**Addendum No. 3 to the
Stanislaus Regional Water Authority
Regional Surface Water Supply Project
Environmental Impact Report**

(SCH No. 2017022077)

May 2021

This Addendum No. 3 to the EIR addresses minor changes to Project design and construction that were not known or fully described at the time the EIR was prepared.

Figure 1.	Regional Surface Water Supply Project Site.....	2-3
Figure 2.	Revised Turlock Tank Site Plan	2-5

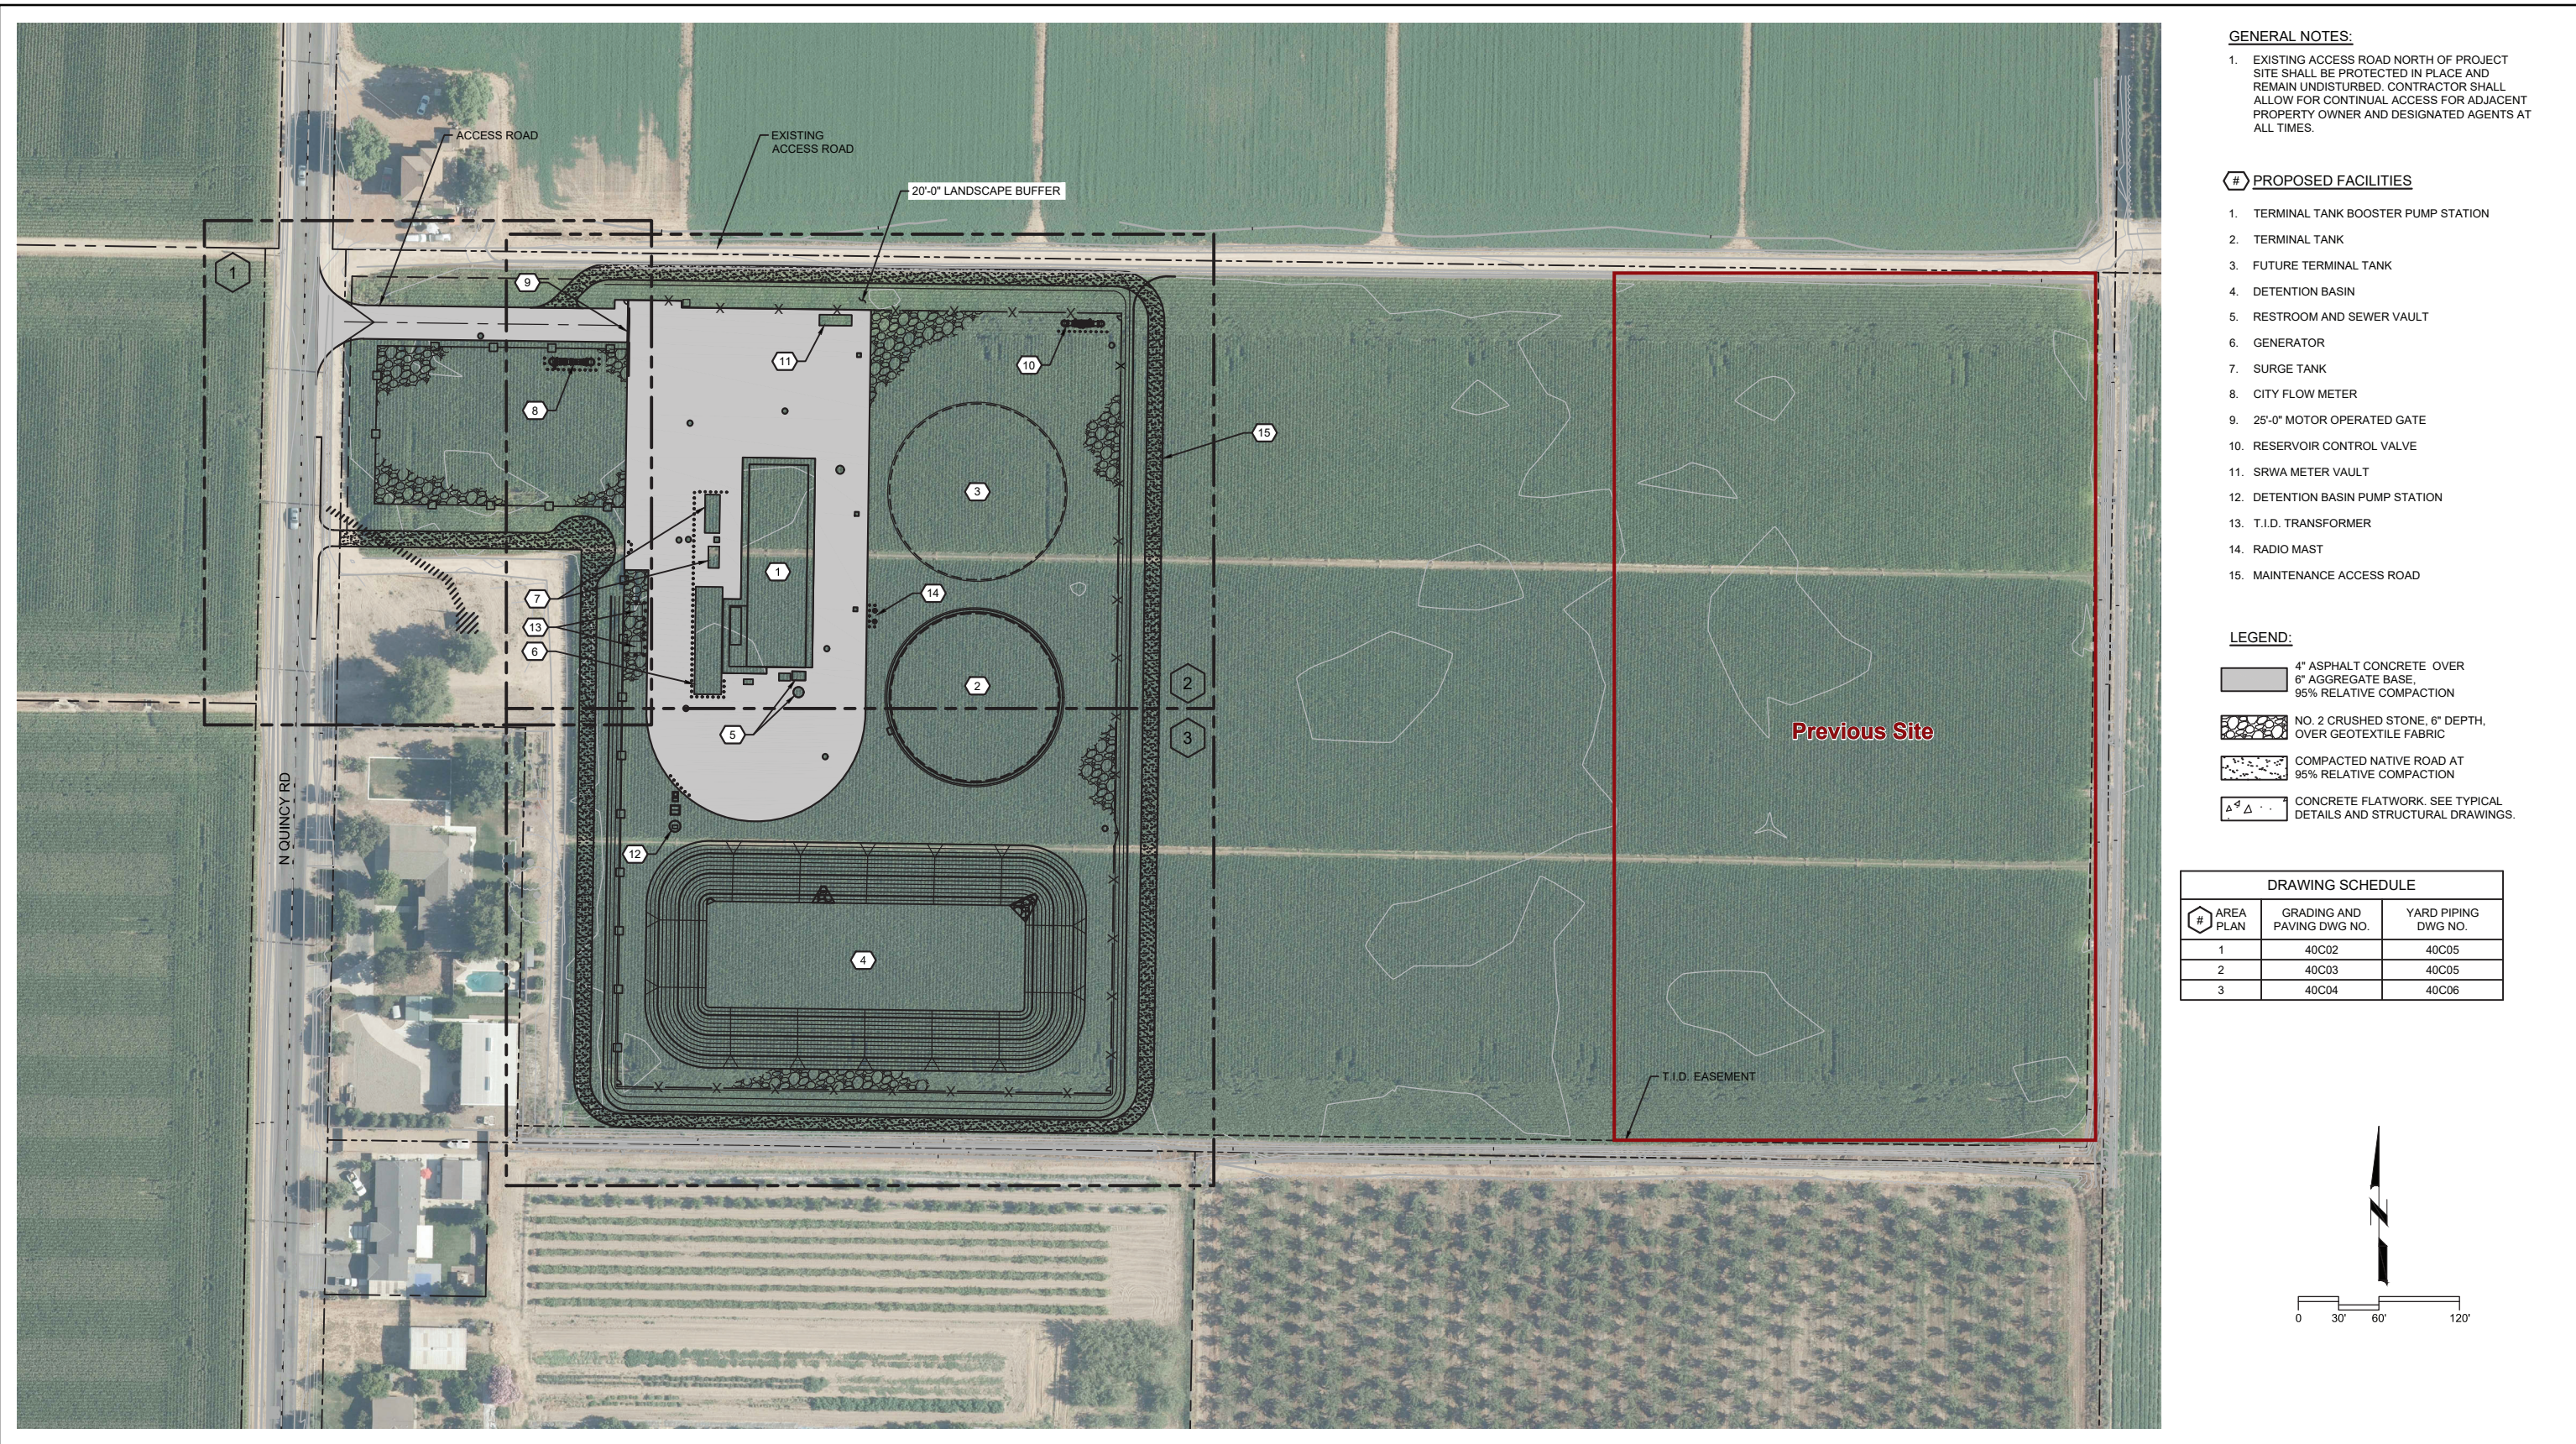
Westward Shift of Turlock Terminal Tank Site: The City of Turlock has negotiated with the owner of the tank parcel to purchase the entire property, rather than only the eastern third of the parcel. This modification allows the City to shift the terminal facilities closer to North Quincy Avenue (**Figure 2**), reducing pipeline construction costs and avoiding additional costs related to the facilities' proximity to TID's canal on the east. Redesign of the site plan includes a setback and landscape buffer from the adjacent residential property to the west, as well as adjustments to the location of the emergency generator and addition of an enclosure for the generator. Additional biological and cultural resource surveys have been conducted to address the entire property.

Increase in Turlock Tank Height: Upon detailed design of the tank facilities, the City's engineers have determined that the tank would be up to 40 feet tall, rather than 30 feet as described in the EIR.

Radio Towers at Ceres and Turlock Tank Sites: Radio towers at each tank site will allow the terminal facilities to communicate with operators at the water treatment plant. The Turlock tower will be 100 feet tall, and the Ceres tower will be 38 feet tall.

The Turlock tank site has been redesigned from the site plan depicted in the EIR, in light of its greater proximity to residential uses. An emergency generator (size KD1250-1750) would be installed at the site within a noise-reducing enclosure (SL2 Sound Enclosure with Internal Silencer and State Code Subbase Fuel Tank); this information is provided in **Appendix D**. The emergency generator at the terminal tank site would be tested for approximately 1-hour periods and for no more than 50 hours per year, in accordance with operating permit conditions.
